# CITY OF ALBUQUERQUE

Hydrology Section Planning Department  
David S. Campbell, Director

**RE: BEK Distribution Facility – 601 Gallatin Pl. NW  
G&D Plan and Drainage Report Engineers Stamp Date: 5/16/2019,  
Hydrology File: FJ10D002G1**

WEST POND

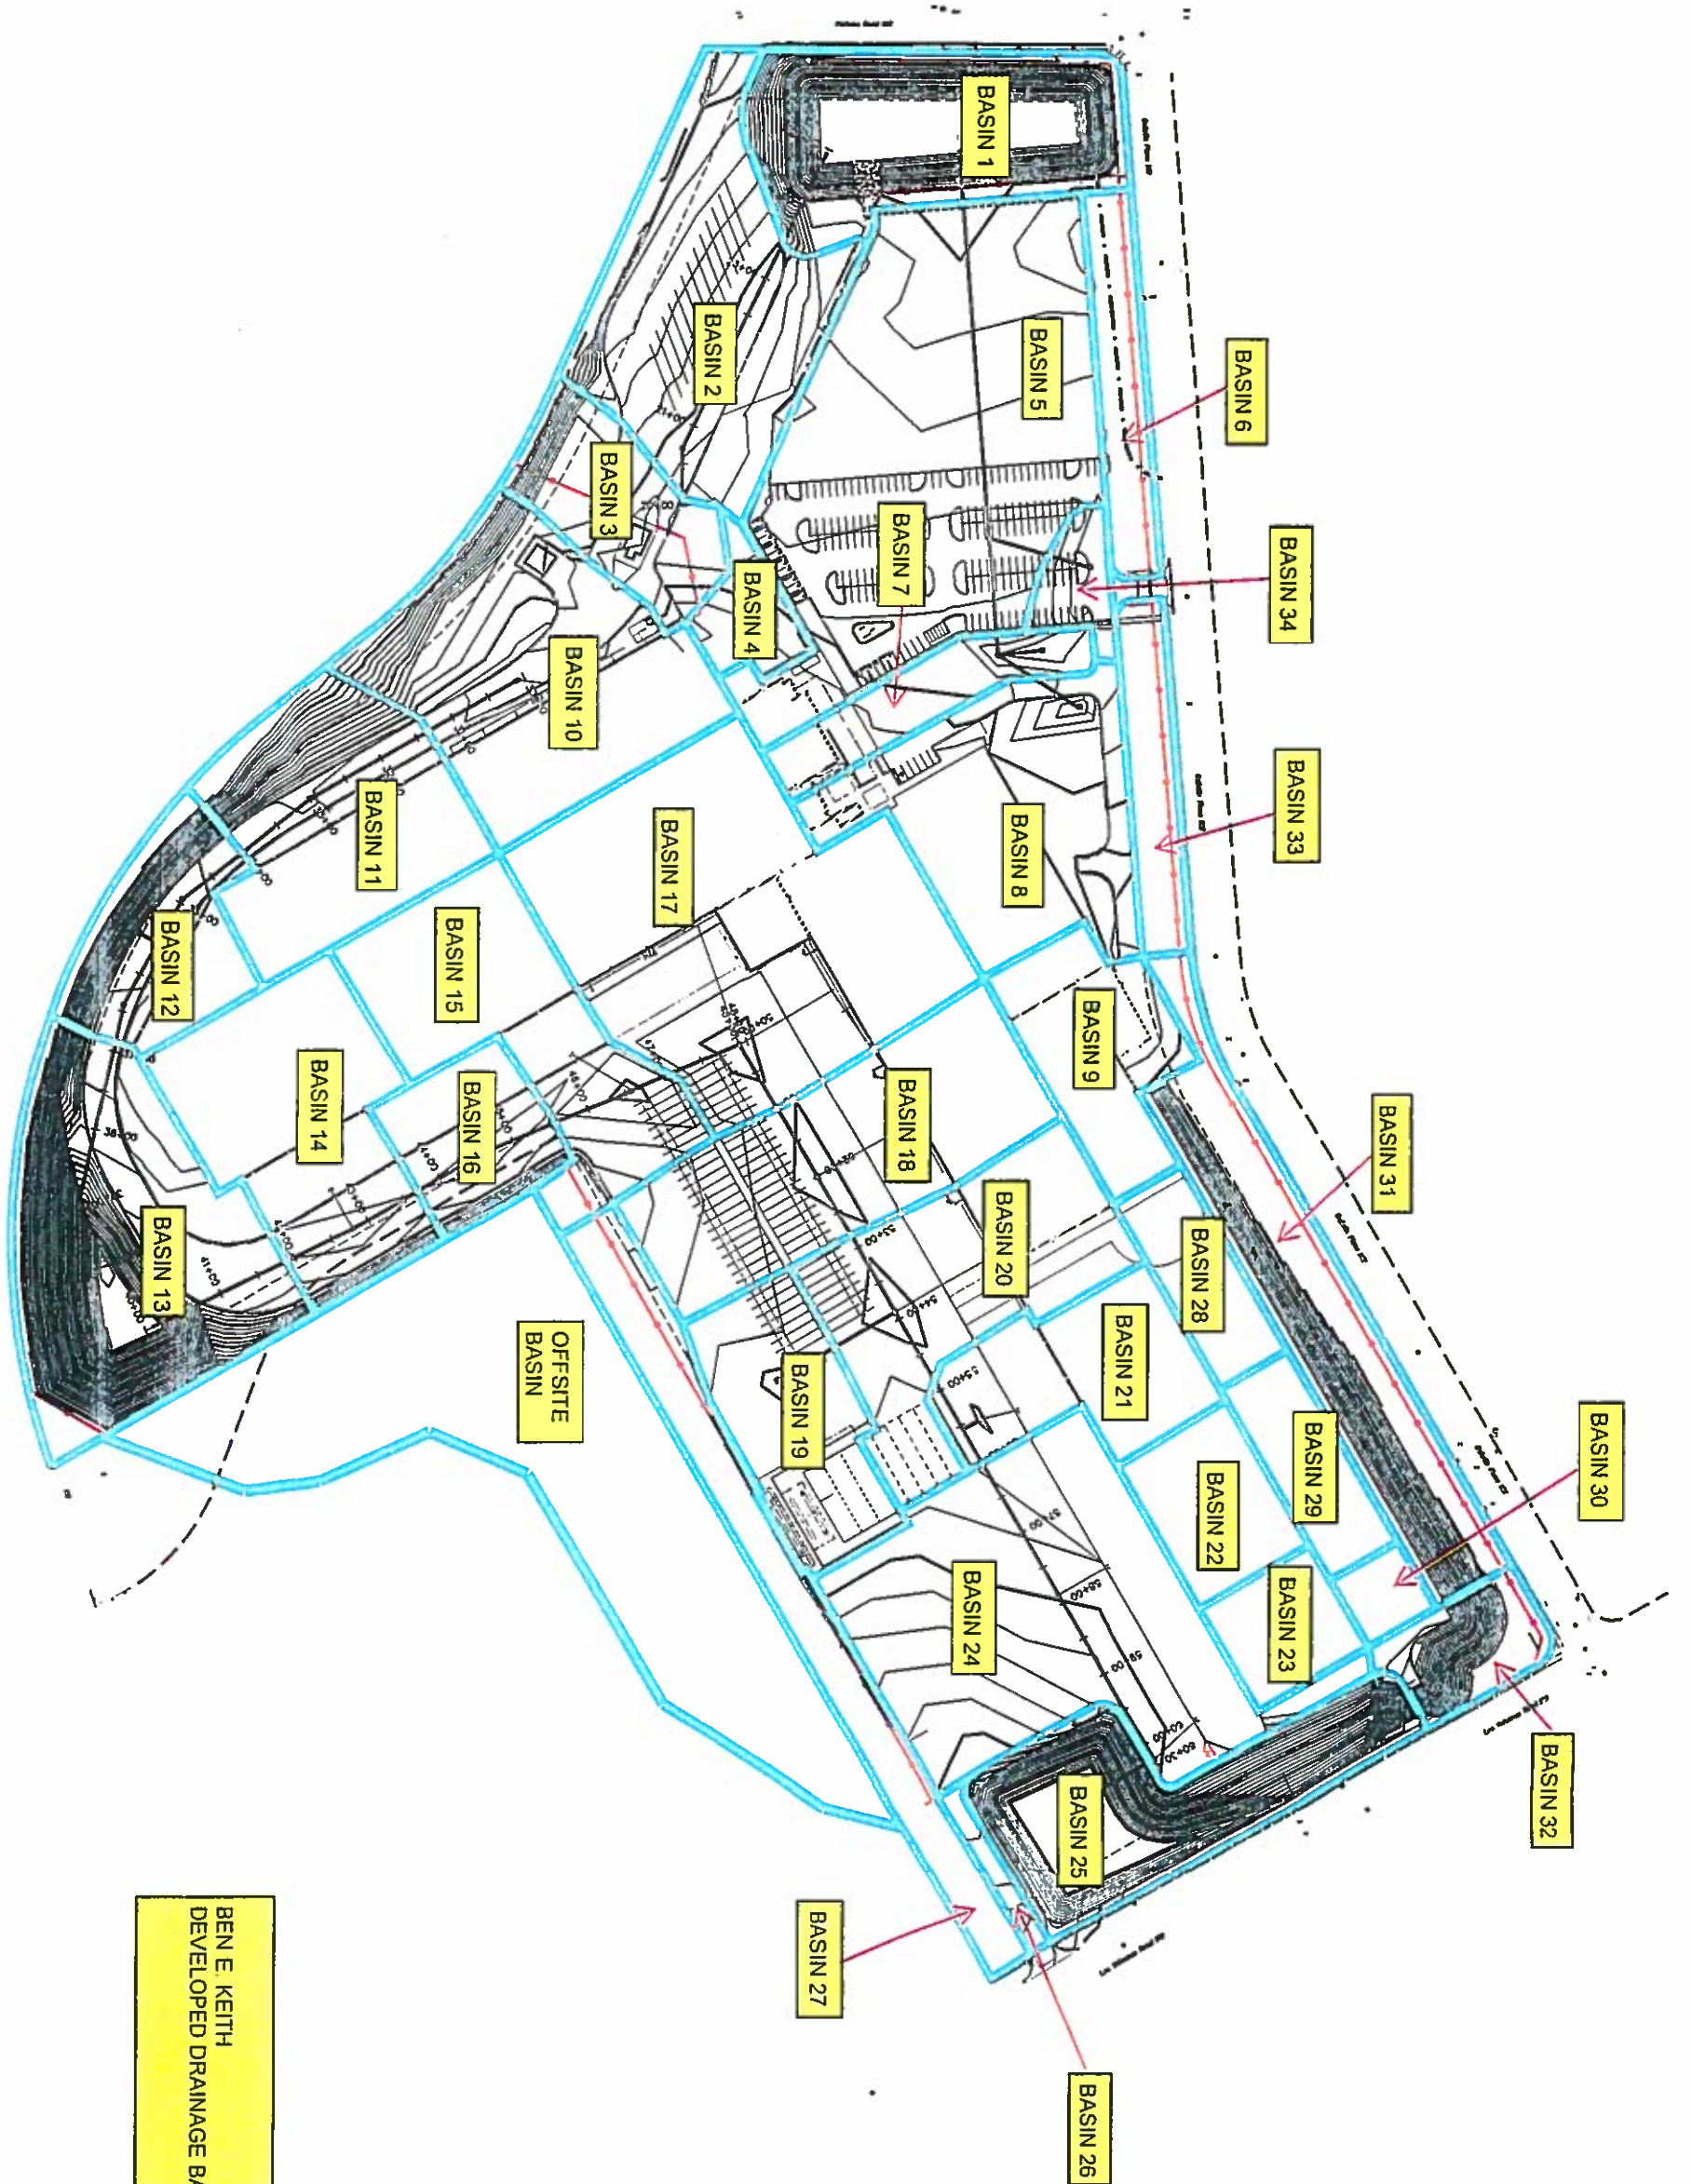
20. Please revise the pond volume calculations to use the Conic approximation method (the volume of a frustum) =  $h/3 \times [b1 + b2 + \sqrt{b1 \times b2}]$  where h is the height between the two areas, and b1 and b2 are the areas of the contours. The method used in the report overestimates the volume of the ponds.
